Access Compliance Report

Public Rights-of-Way

(Curb Ramps)

Intersection ID: 27963	Main Street: FAIR_ISLE_DR	Cross Street: MCGINN'S_TRACE_CT	Location: SW
ADA ID: 3C76C6A13694	Ramp Type: BlendTrans1	Initial Pass/Fail: Fail	Overall Compliance: No
		Severity Score: 25

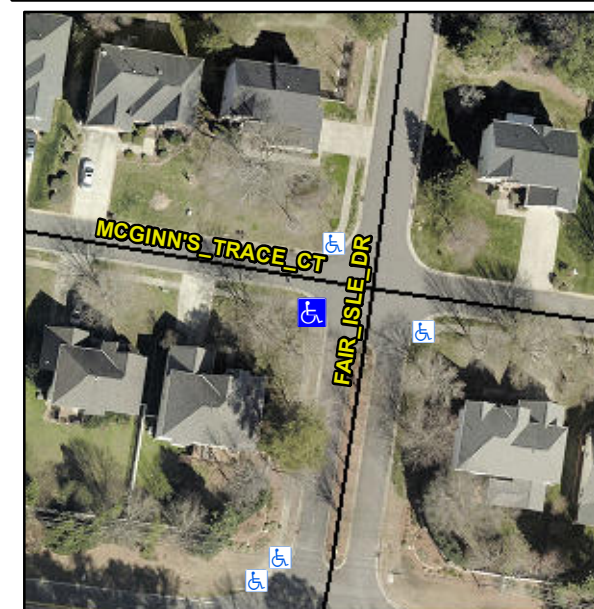
Not Found, R304.5.3

Compliance	Description	Data	Compliance	Description	Data
N/A	Ramp Length (in)	48.0	Yes	BlendTrans Slope (%)	2.1
Yes	Ramp Width (in)	48.0	No	BlendTrans XSlope (%)	9.2
N/A	Flare Type LT	N/A	N/A	Flare Type RT	N/A
N/A	Flare Slope LT (%)	N/A	N/A	Flare Slope RT (%)	N/A
N/A	Flare Traversable LT?	N/A	N/A	Flare Traversable RT?	N/A
N/A	Landing Length (in)	N/A	N/A	DWS Provided?	N/A
N/A	Landing Width (in)	N/A	N/A	DWS Contrast?	N/A
N/A	Landing Slope (%)	N/A	N/A	DWS Length (in)	N/A
N/A	Landing X Slope (%)	N/A	N/A	DWS Full Width?	N/A
N/A	Landing Curb? (Y/N)	N/A	N/A	DWS Offset (in)	N/A
N/A	Shared Landing?	N/A			
N/A	Gutter Ponding?	N/A	N/A	Gutter Slope (%)	N/A
N/A	Gutter Lip Ht (in)	N/A	N/A	Gutter X Slope (%)	N/A
N/A	Painted X Walk1?	No	N/A	Painted X Walk2?	No
	X Walk 1 Direction	To E		X Walk 2 Direction	To N
	X Walk 1 Width (in)	N/A		X Walk 2 Width (in)	N/A
	X Walk 1 Slope (%)	0.2		X Walk 2 Slope (%)	8.2
	X Walk 1 X Slope (%)	10.5		X Walk 2 X Slope (%)	2.7

Remove & Replace Curb Ramp With Two New Directional Ramps or Equivalent.
